Bid Addendum

Addendum No. 3 for the City of Staunton Johnson, Byers, and New Street Tunnel Repairs.

Addendum Date: November 10, 2025

CITY OF STAUNTON
JOHNSON, BYERS, AND NEW
STREET TUNNEL REPAIRS
STAUNTON, VIRGINIA

SHEET TITLE
ENLARGED PLAN - JOHNSON STREET CROSSING

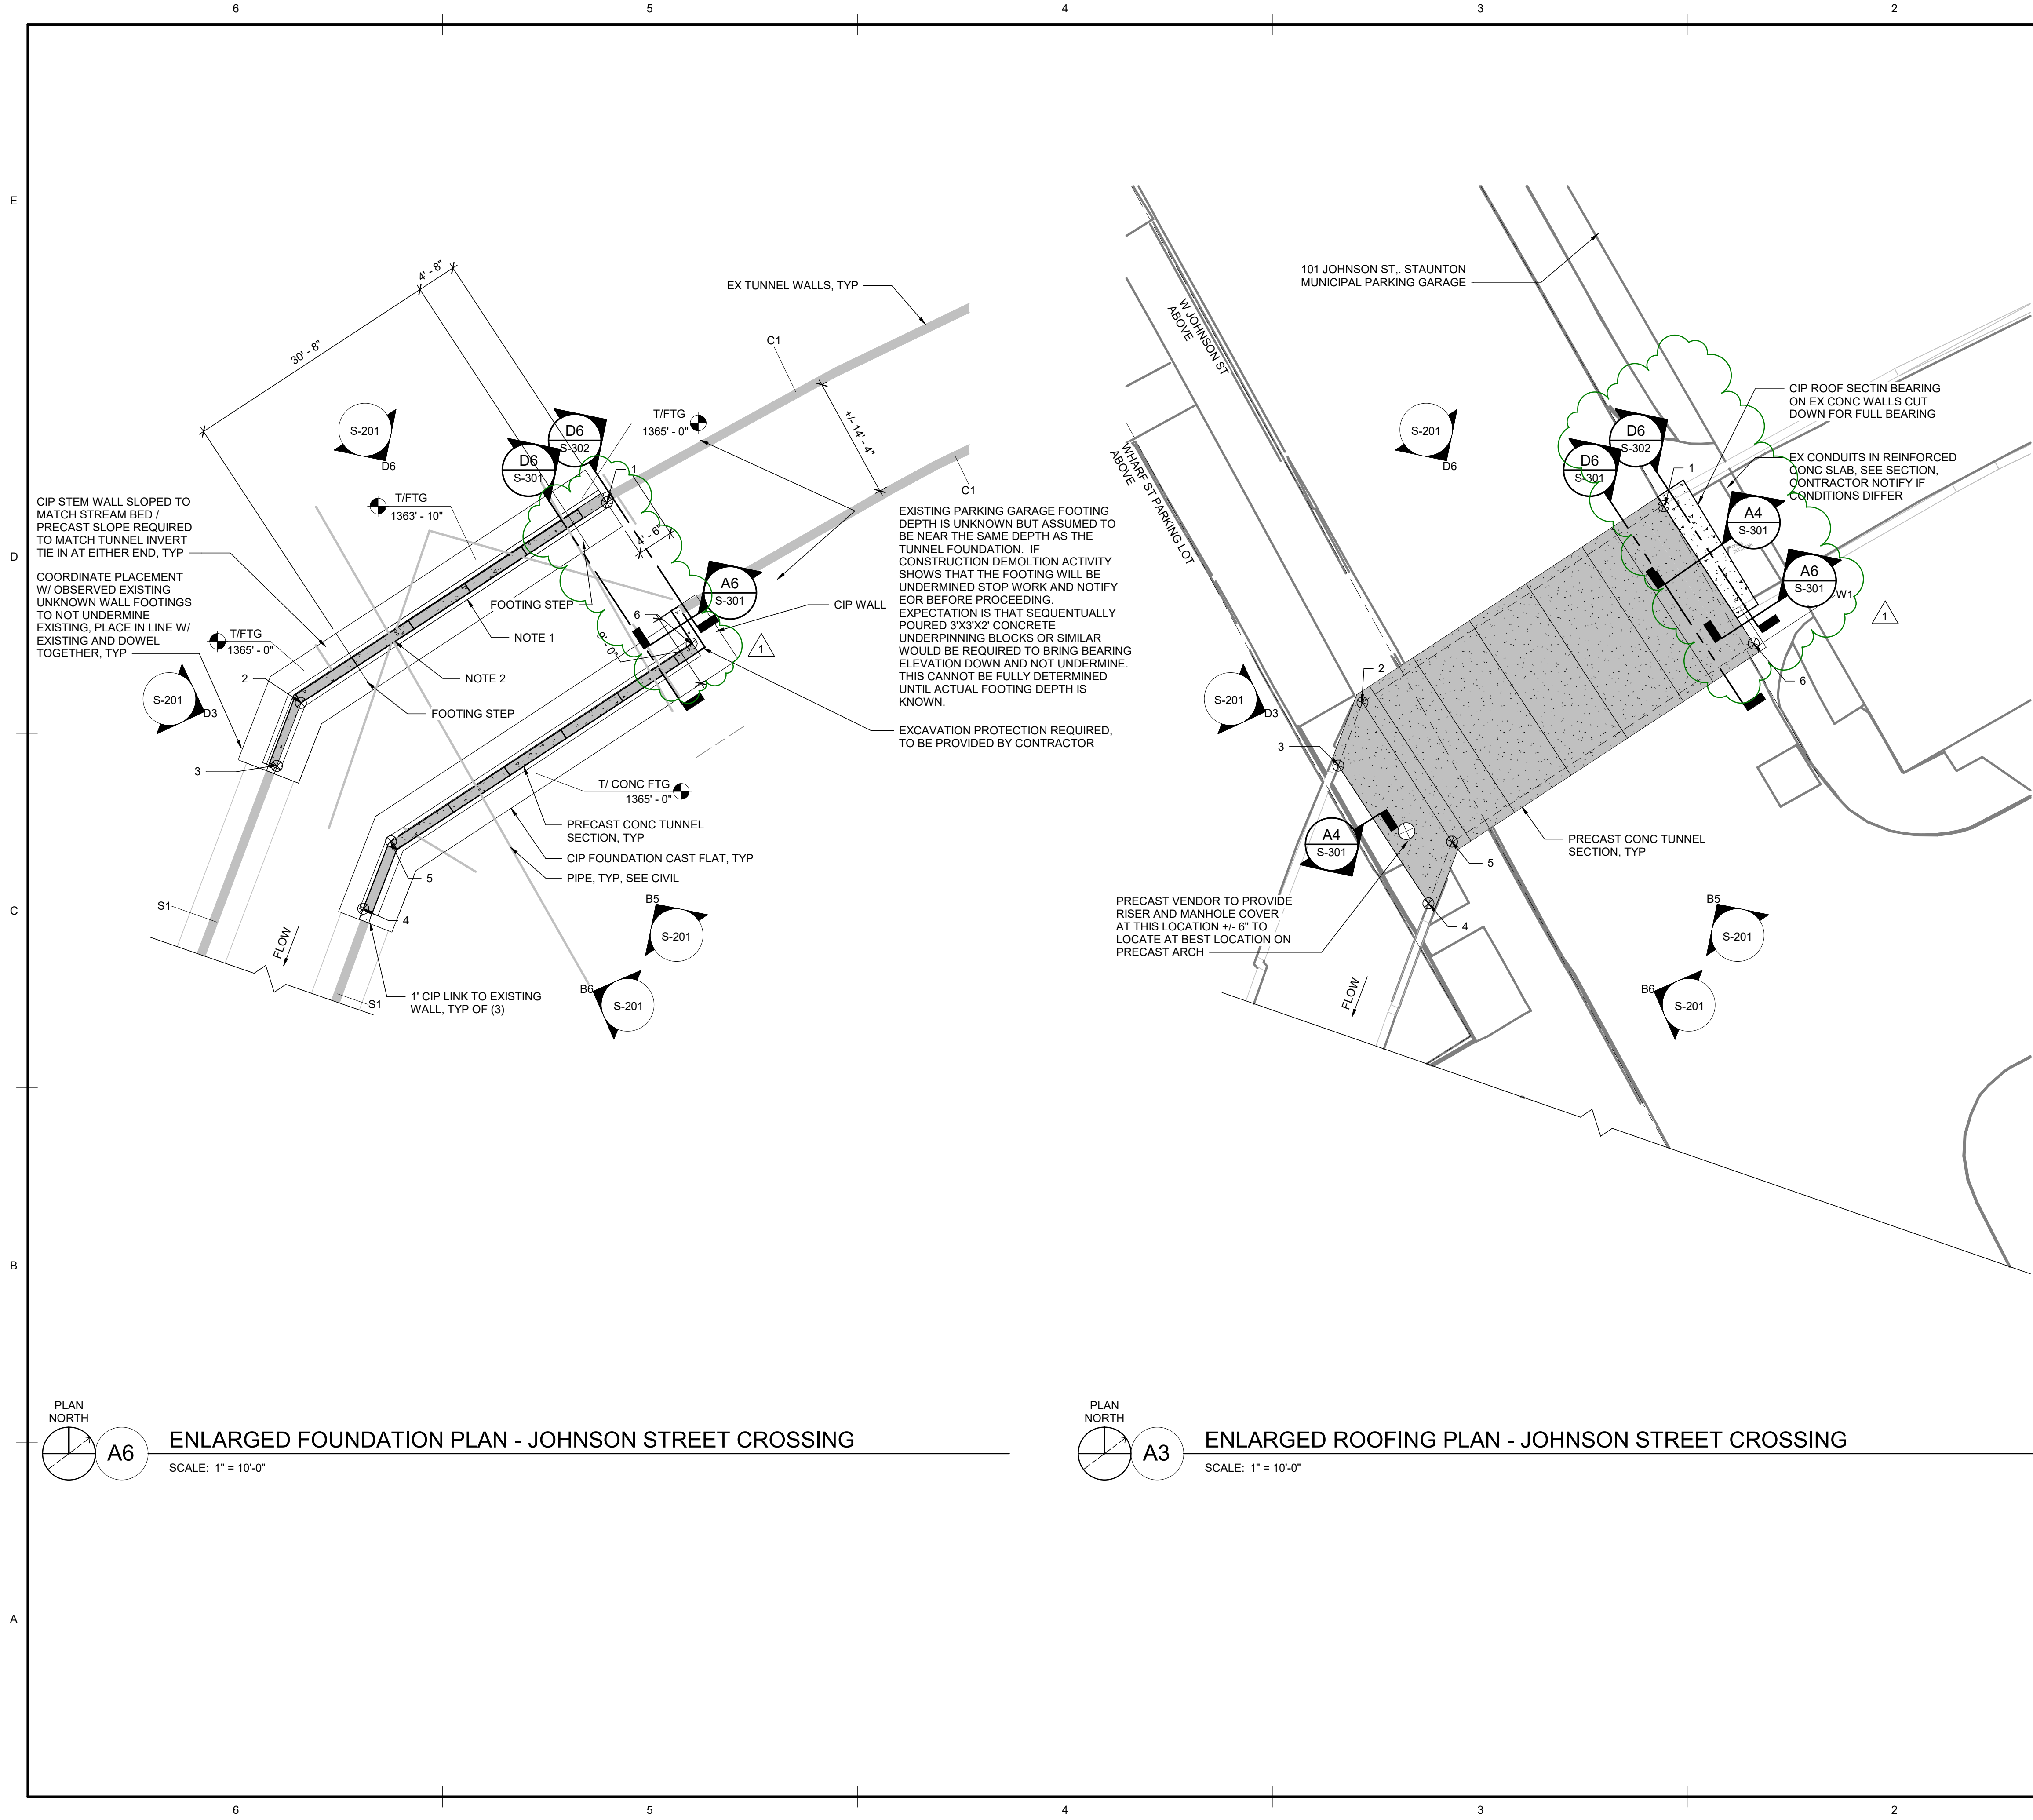
Drawing S-401: Has been reissued to revise precast concrete plan near the garage entrance along Johnsons Street.
